**NEW YORK STATE THRUWAY AUTHORITY  
DEPARTMENT OF ENGINEERING**

**AMENDMENT NO. 2  
TO**

**CONTRACT TANY 26-17B  
D215020  
REPLACEMENT OF THE PINE HILL ROAD  
BRIDGE OVER I-87 AT MP 47.58,  
REHABILITATION OF I-87 BRIDGE OVER  
SMITH CLOVE ROAD AT MP 47.04,  
AND RESURFACING AND SAFETY IMPROVEMENTS  
ON I-87 BETWEEN MP 46 AND MP 48  
IN THE NEW YORK DIVISION  
OF THE NEW YORK STATE THRUWAY  
IN ORANGE COUNTY**

**IN THE LETTING OF  
JUNE 17, 2026**

TITLE OF PROJECT 1-87 BRIDGE REHABILITATION OVER SMITH CLOVE ROAD (MP 47.04)	CONTRACT NUMBER: TANY 26-17B
LOCATION OF PROJECT VILLAGE OF WOODBURY ORANGE COUNTY BIN 5514279	DATE: 05/21/2025
TITLE OF DRAWING PROPOSED DECK AT OVERHANG SIDE	DRAWING NUMBER: PD-1

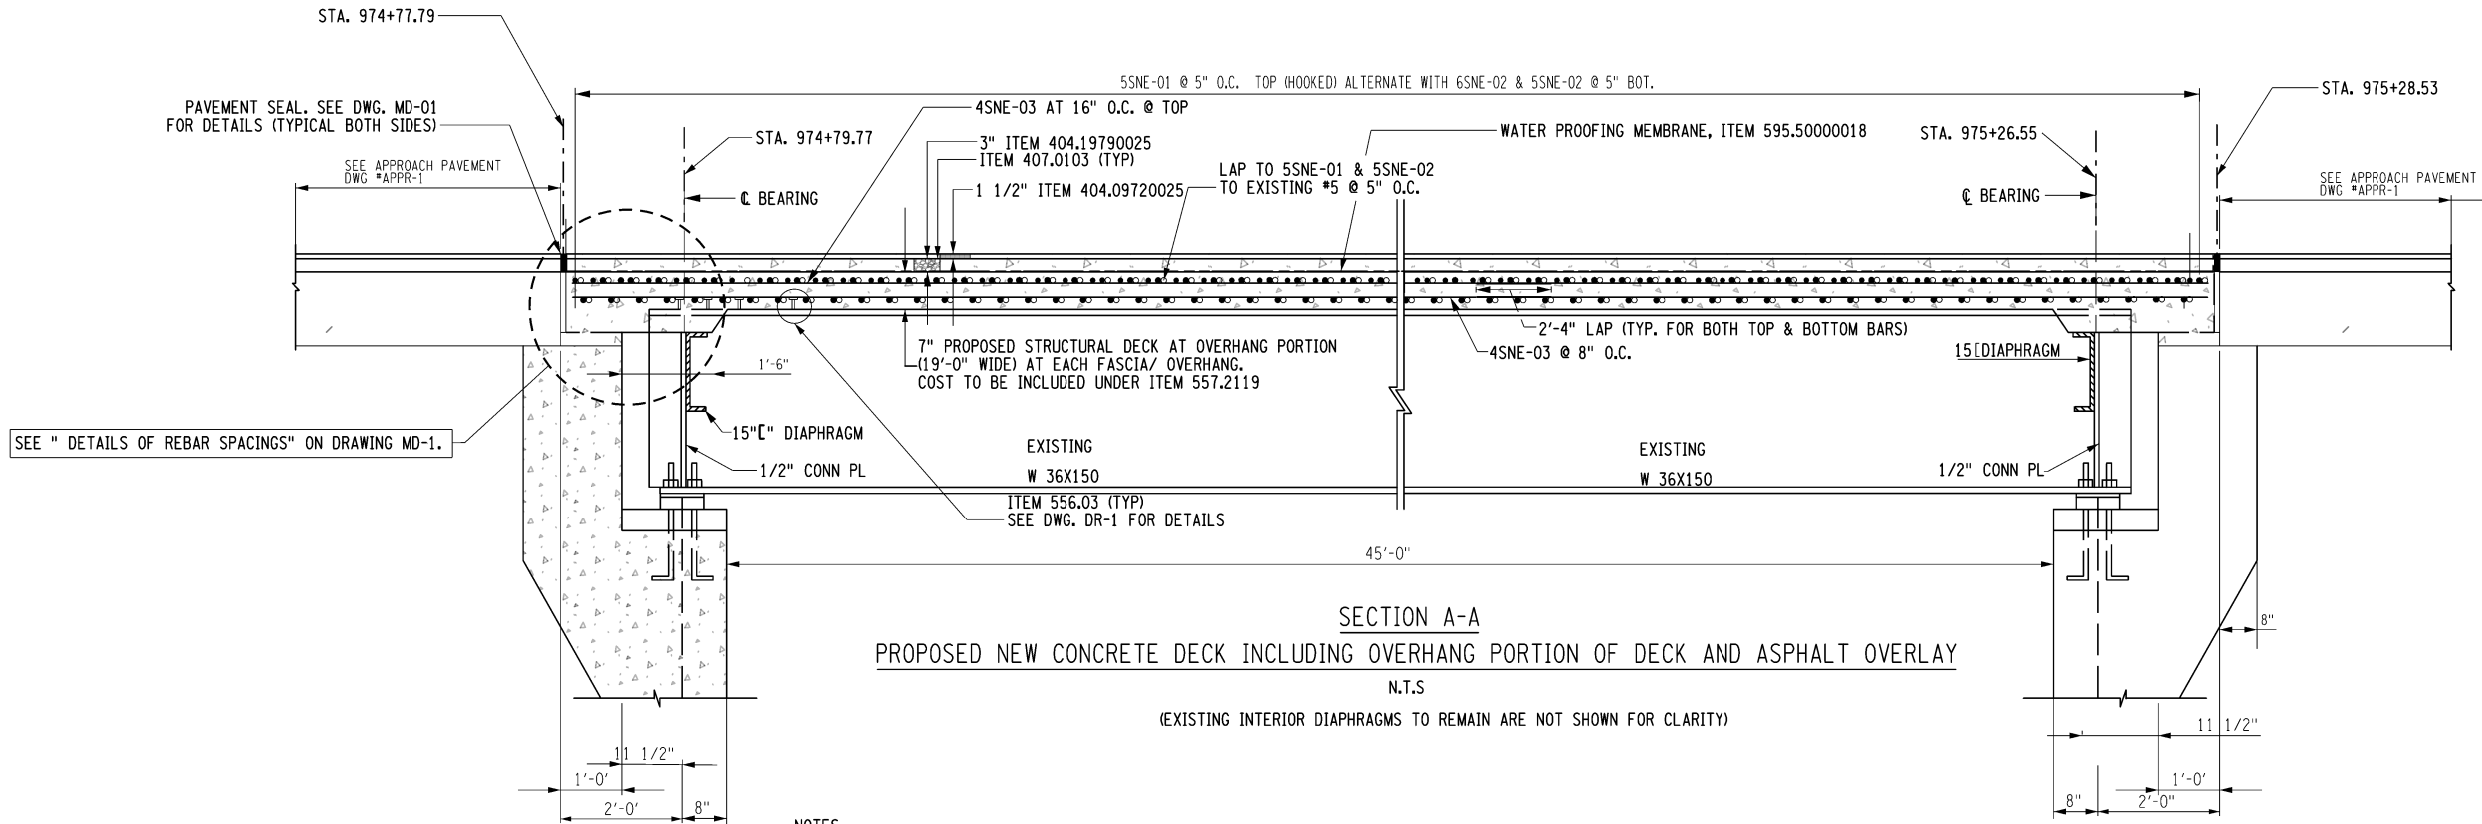
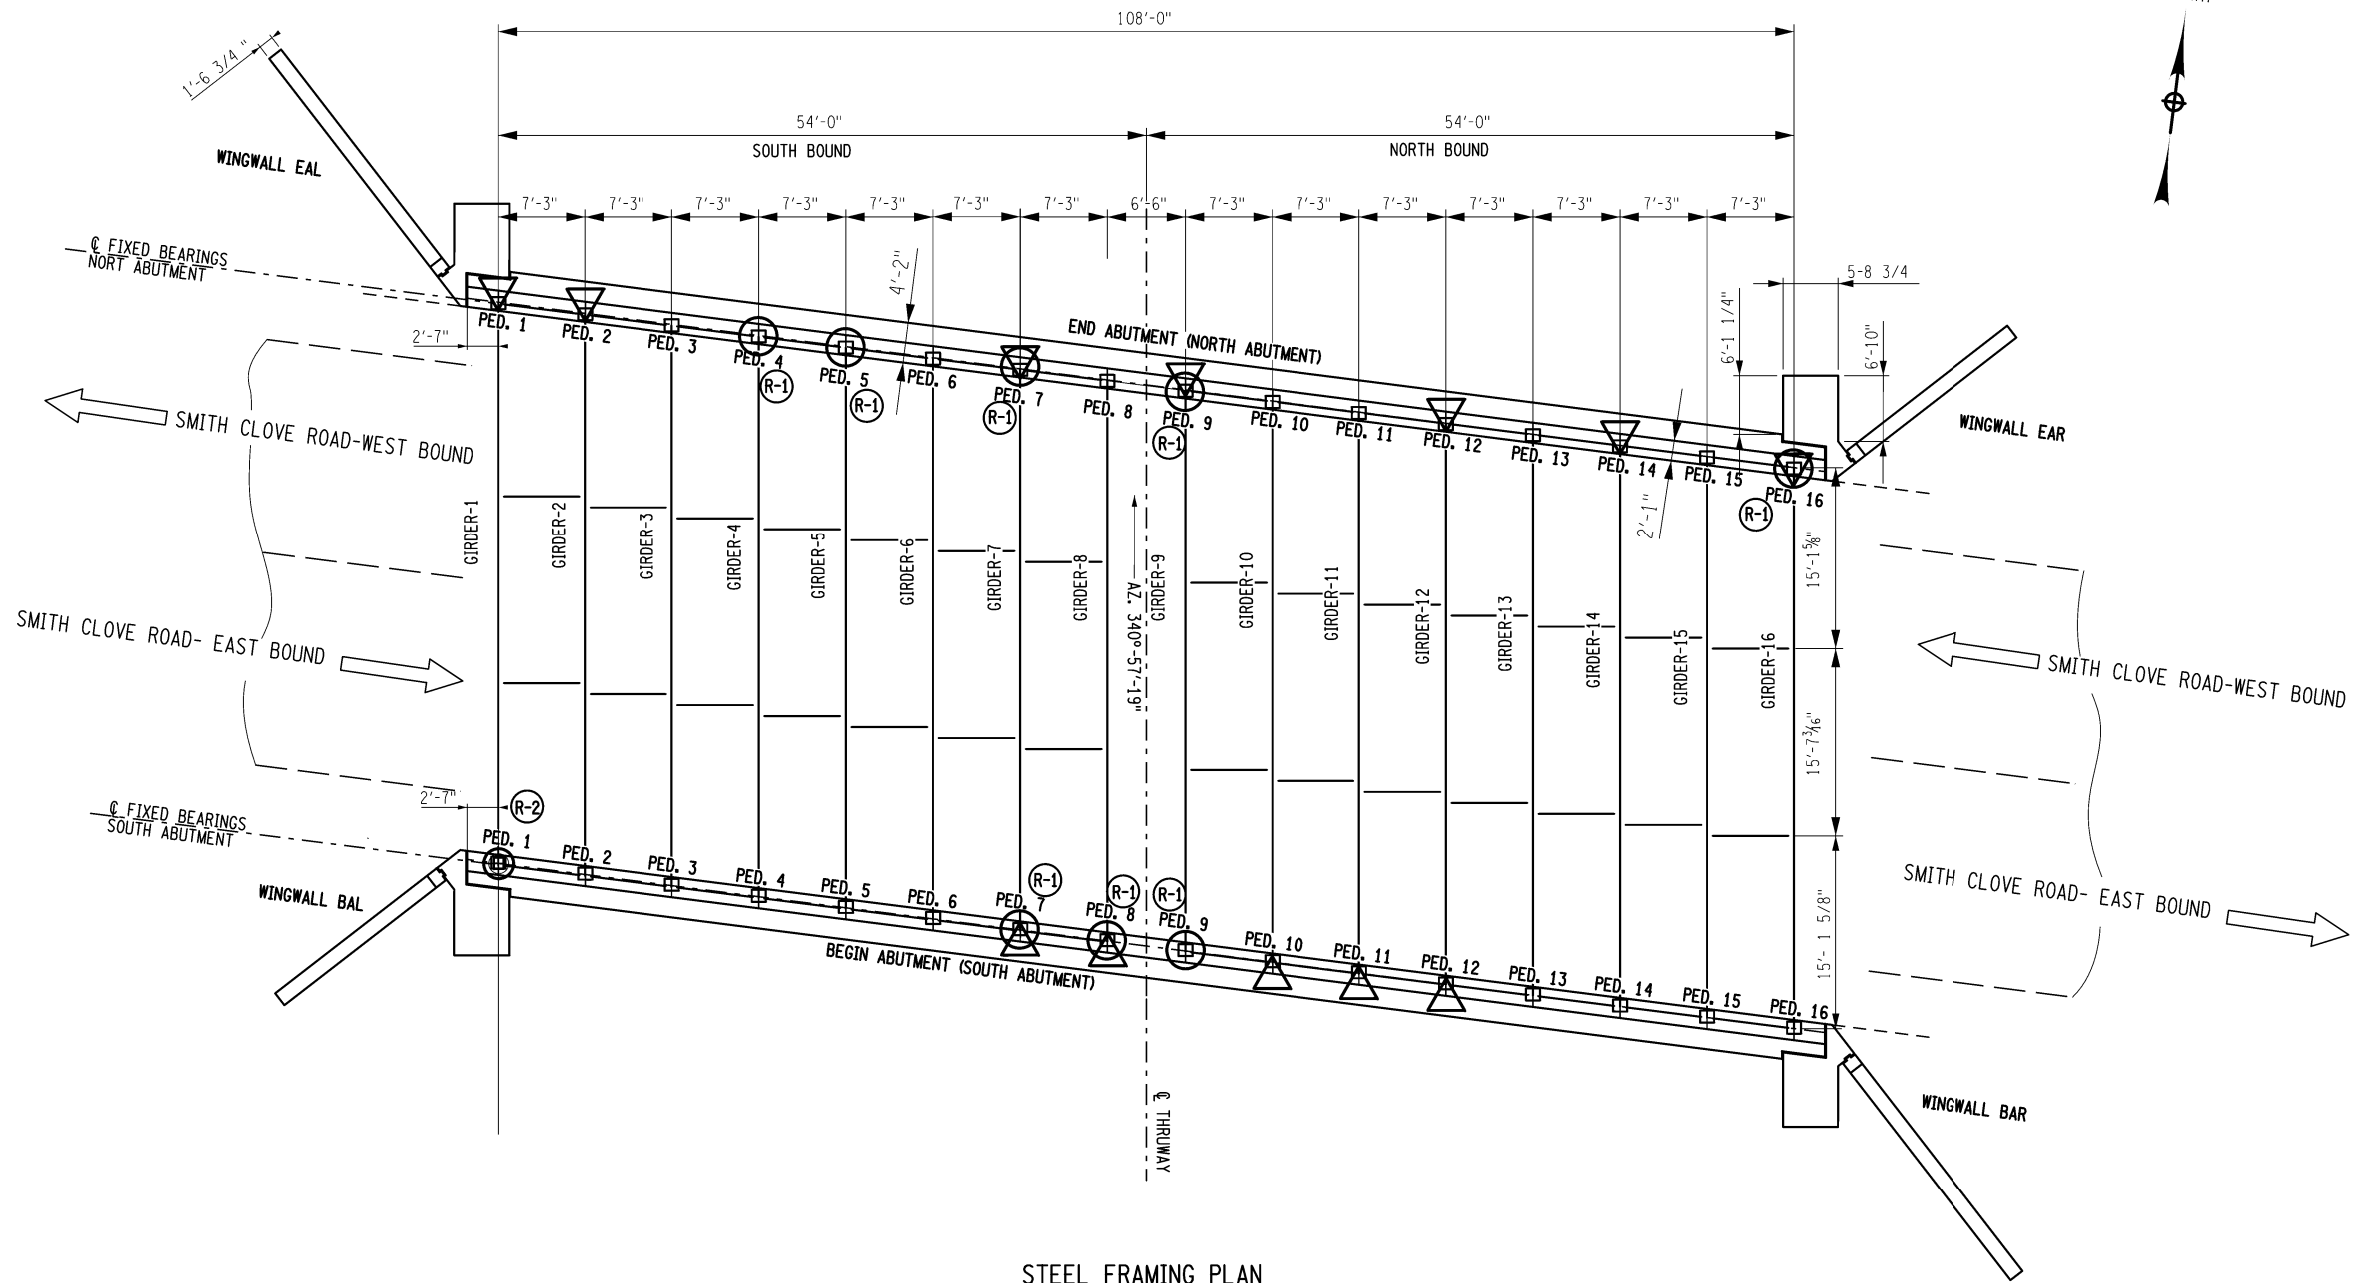
26. **DELETE** Drawing Number PD-1, Sheet 155 of 180, and **SUBSTITUTE** with the attached Drawing Number PD-1, Sheet 155A2 of 180. In the Section A-A Proposed New Concrete Deck Overhang Portion of Deck and Asphalt Overlay detail, the previous callout to the preformed closed cell cross-linked joint seal, Item 567.63, has been replaced with a pavement seal on both sides. Steel reinforcement bar marks, and Notes 1 through 4 have been revised.

CONTRACT NUMBER:  
TANY 26-17B  
DATE:  
05/21/2025  
DRAWING NUMBER:  
SFP-1

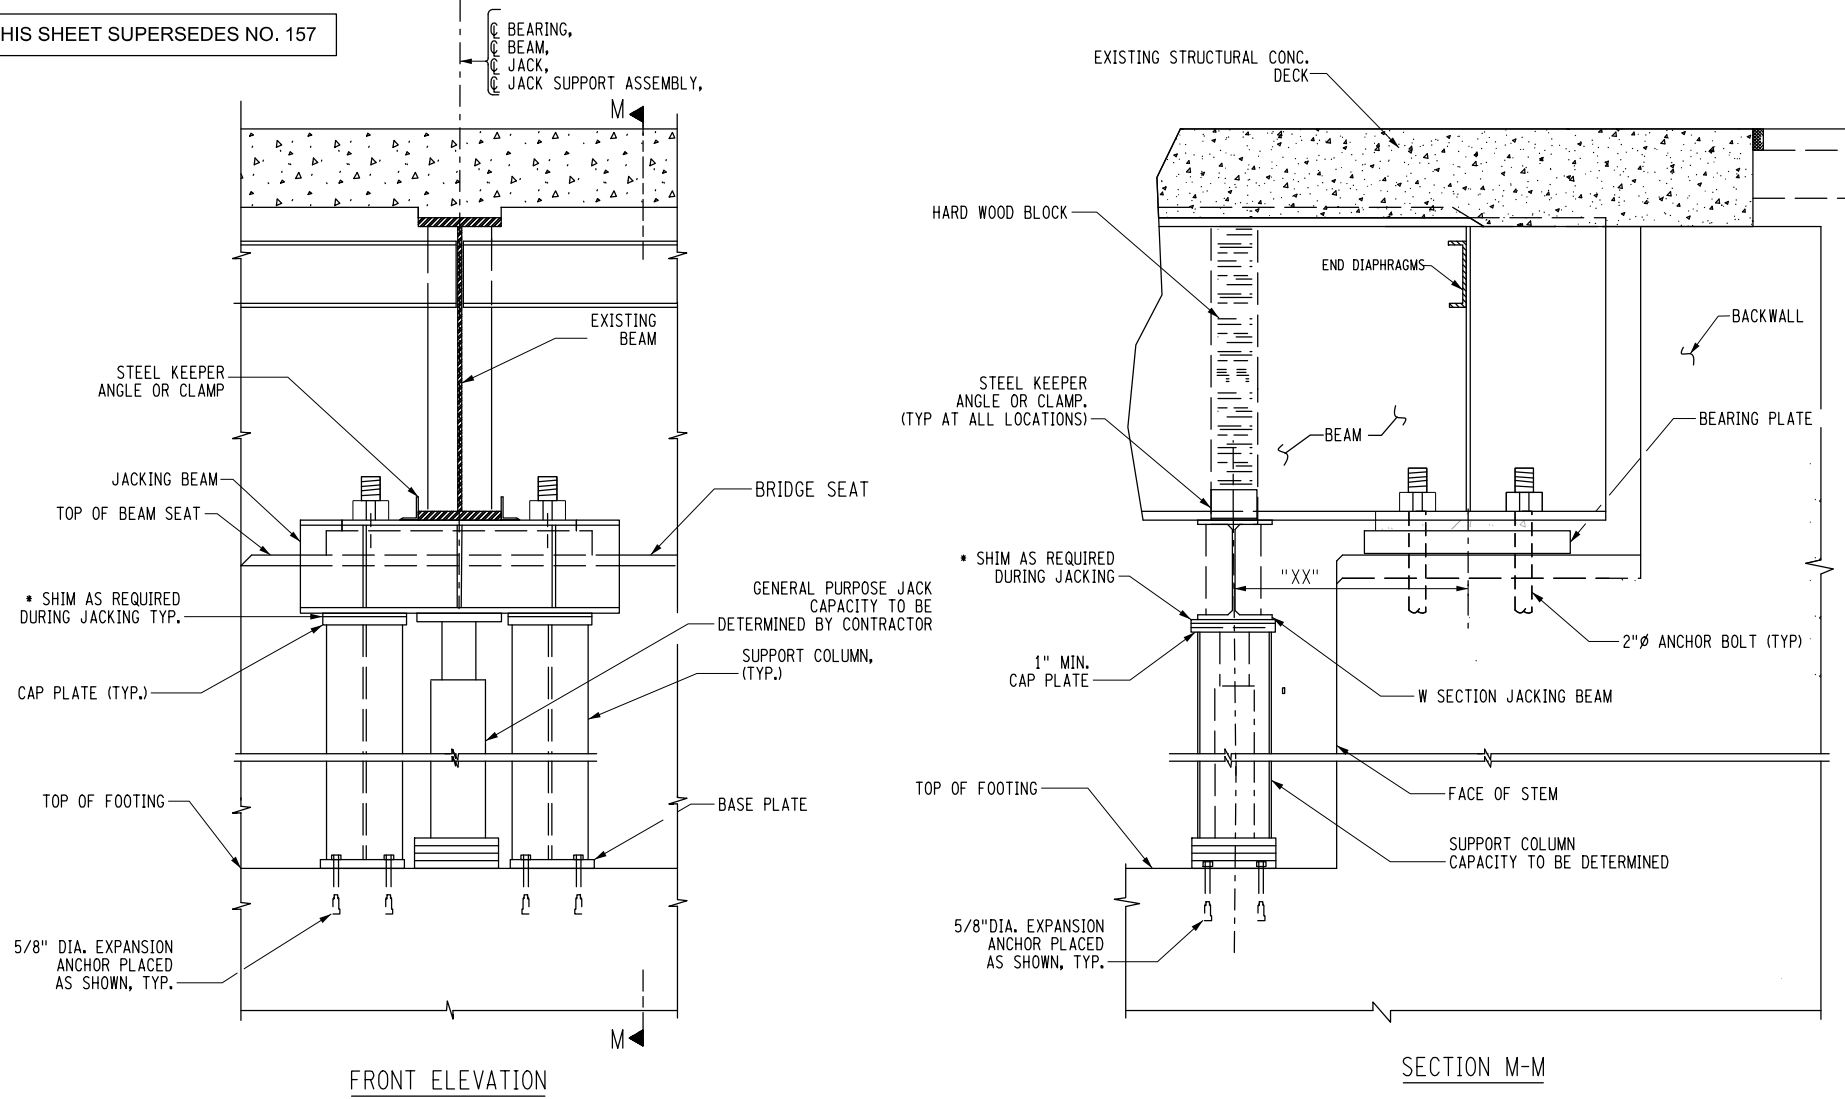
27. **DELETE** Drawing Number SFP-1, Sheet 156 of 180, and **SUBSTITUTE** with the attached Drawing Number SFP-1, Sheet 156A2 of 180. Previous references to Limits of Header Reconstruction on both abutments have been removed from the Steel Framing Plan. The pedestal numbers on the end (north) abutment have been revised.

DRAWING NUMBER:  
**GLO-1**

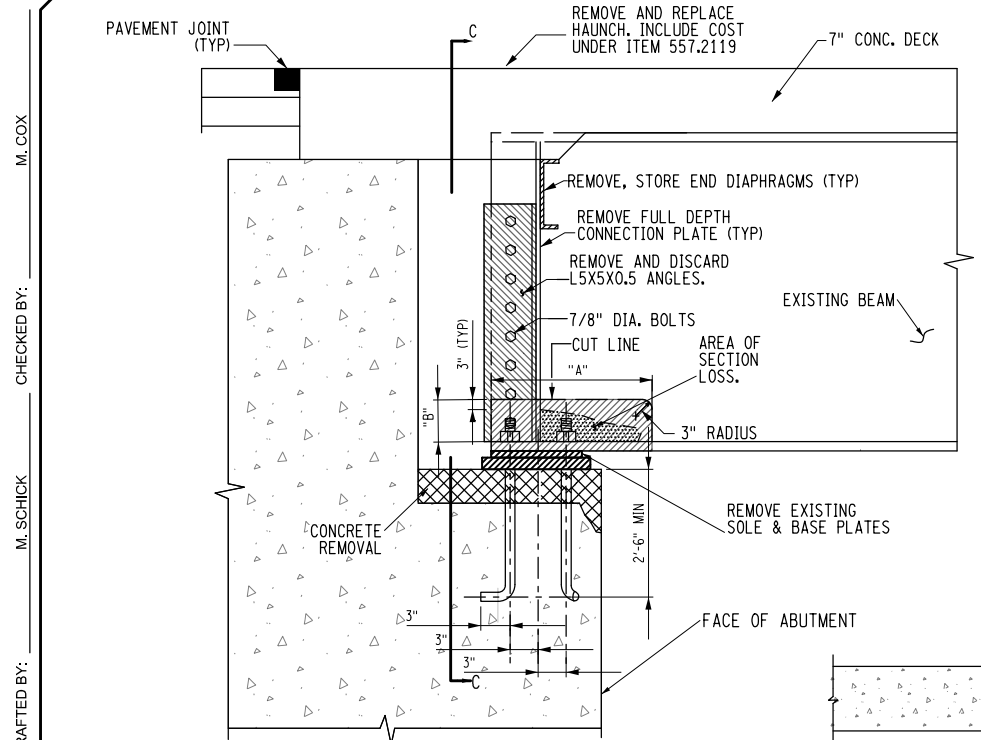
28. **DELETE** Drawing Number GLO-1, Sheet 157 of 180, and **SUBSTITUTE** with the attached Drawing Number GLO-1, Sheet 157A2 of 180. The General Purpose Jack Capacity callout note in the Front Elevation detail has been updated.

DRAWING NUMBER: SRD-1

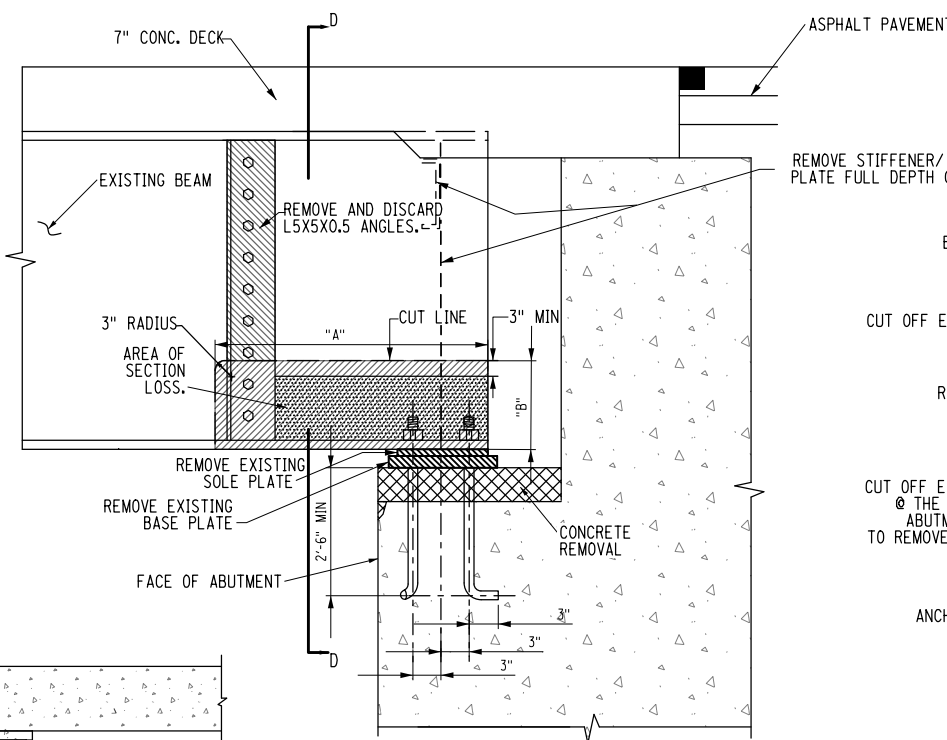
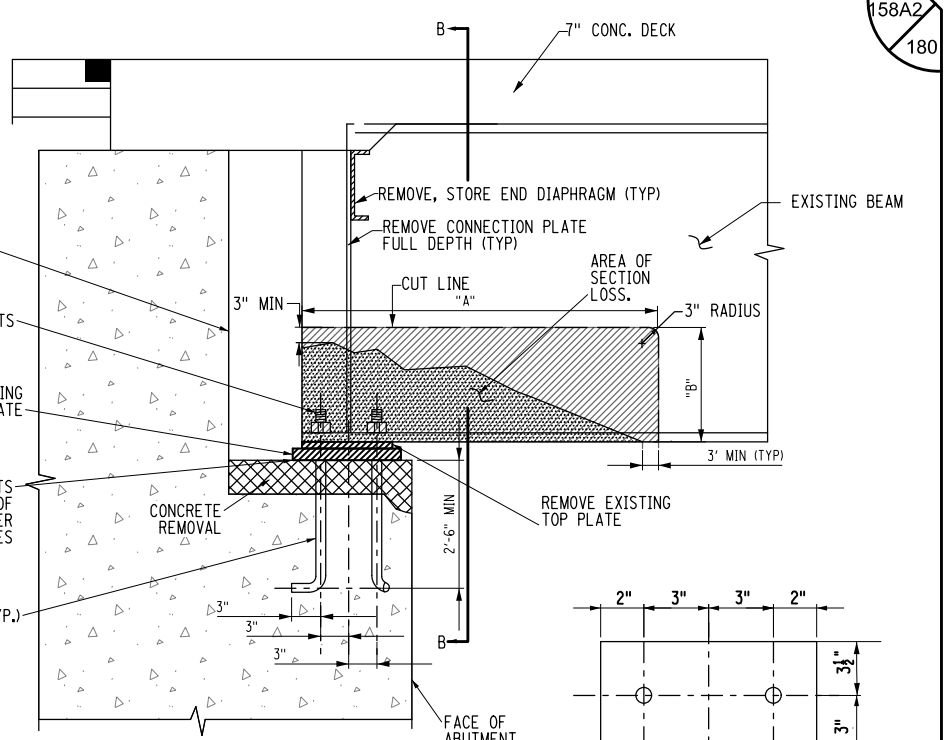
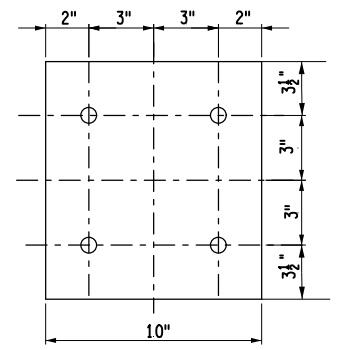
29. **DELETE** Drawing Number SRD-1, Sheet 158 of 180, and **SUBSTITUTE** with the attached Drawing Number SRD-1, Sheet 158A2 of 180. In all three of the Type-R1 and Type-R2 Repair of Girders details, the hatch mark on the concrete deck have been removed, and each of the pavement joint details have been revised. The Repair Procedure for Smith Clove Road Note 3 has been updated to now reference a pay item to account for the paint removal costs.

DRAWING NUMBER: SRD-2

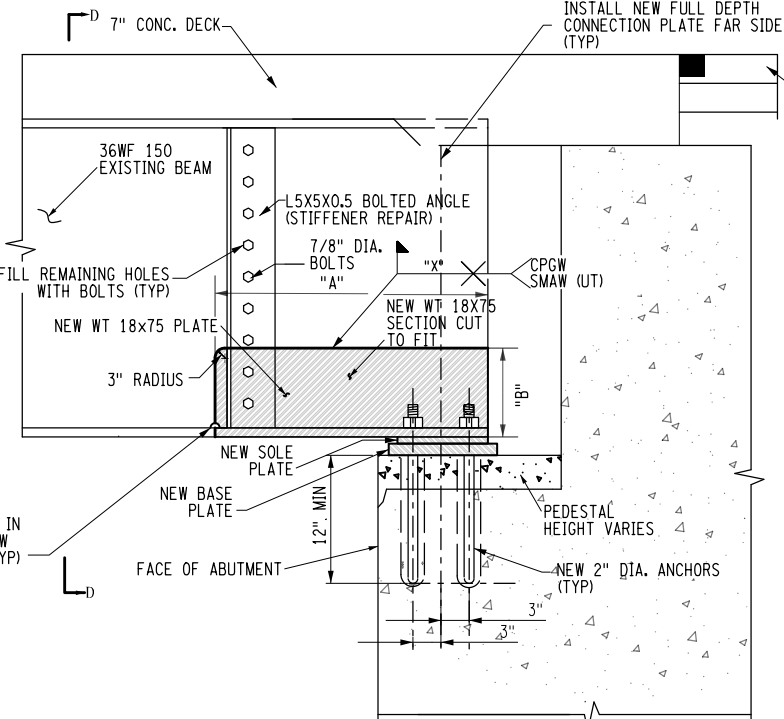
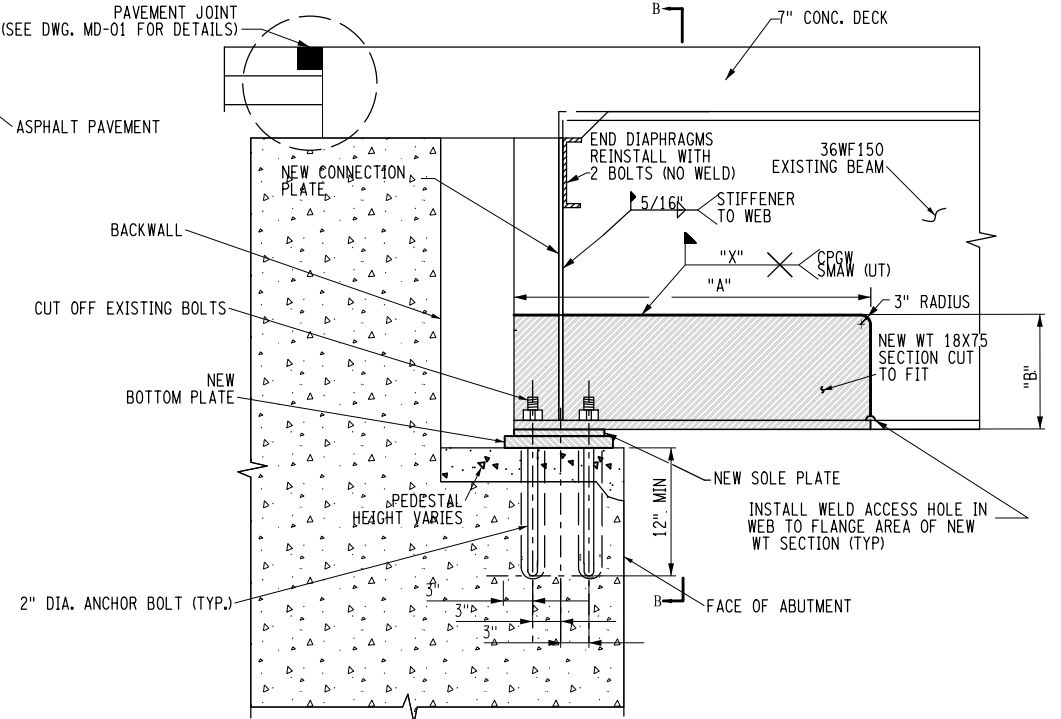
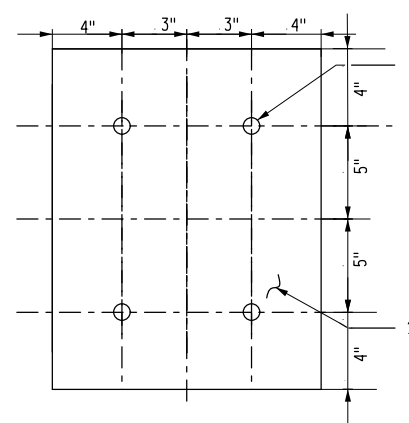
30. **DELETE** Drawing Number SRD-2, Sheet 159 of 180, and **SUBSTITUTE** with the attached Drawing Number SRD-2, Sheet 159A2 of 180. In all three of the Type-R1 and Type-R2 Repair of Girders details, the hatch mark on the concrete deck have been removed, and each of the pavement joint details have been revised. Lastly, Notes 3 and 4 have been revised to clarify what is to be included and paid for under the steel paint removal, steel painting and containment items.
